Buildings - South Kanara - Udipi - Govt. Hospital - Quarters of the nurse, midwife and menials - construction of septic tank latrines- revised estimate amounting to Rs. 1370 - approved.

Subject:- Buildings - Government Hospital, Udipi - Quarters of the nurse, midwife and menials - construction of latrines.

Buildings – Govt Hospital – South Kanara – Udipi – Quarters of the nurse, midwife and menials – Construction of Septic tank latrines

ROUGH PLAN
SHOWING
THE POSITION OF HOSPITAL COMPOUND & STAFF QRS COMPOUND
IN
GOVT HOSPITAL AT UDIPI.
NOT TO SCALE.

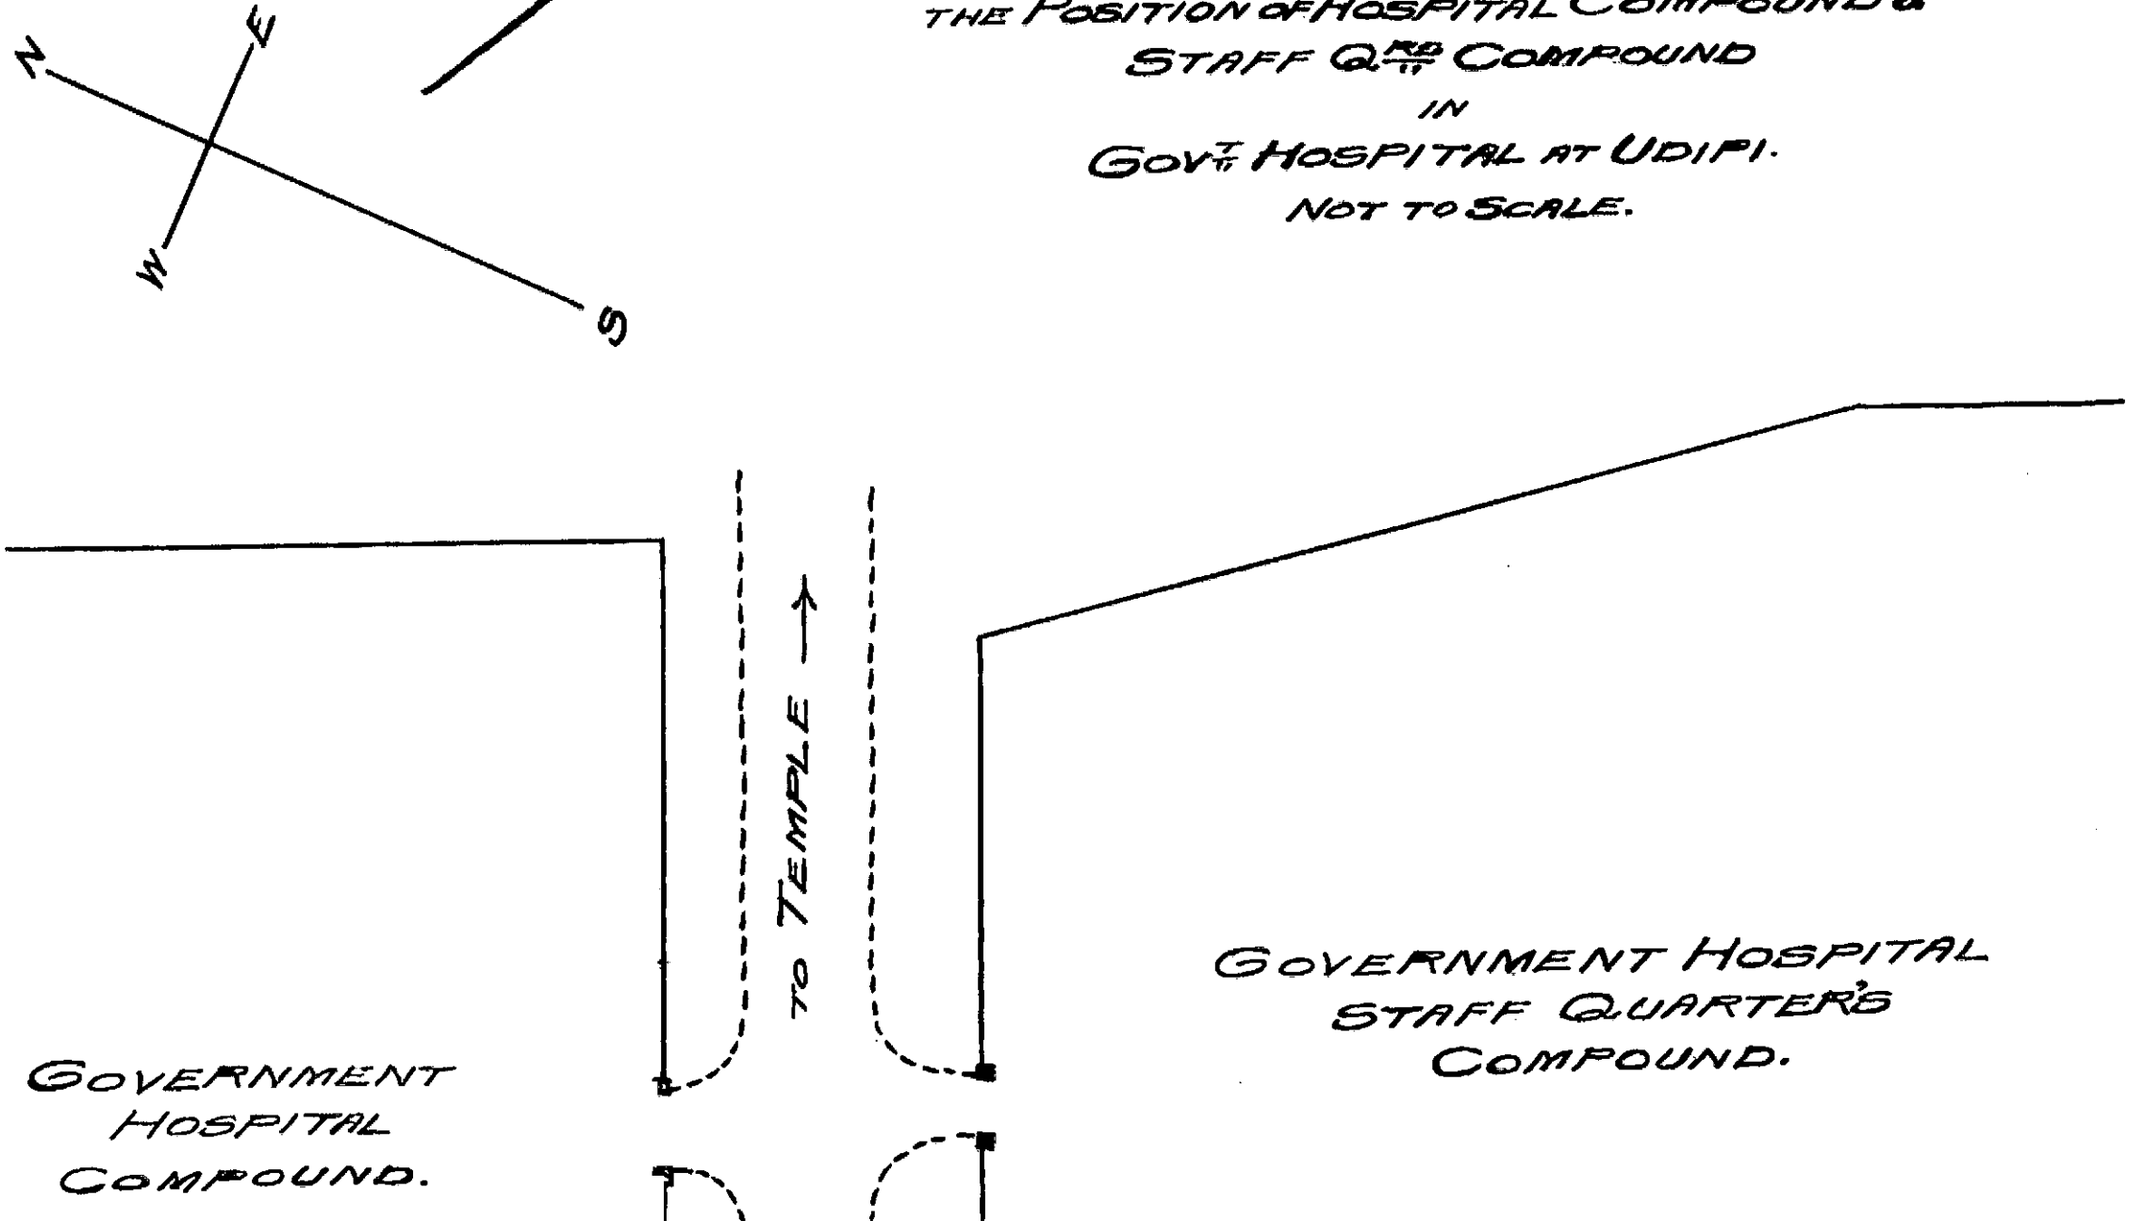
The quarters mentioned above are outside the Hospital compound.

A rough sketch showing the relative positions of the hospital and the quarters is also sent for information with post copy of the telephonic message.
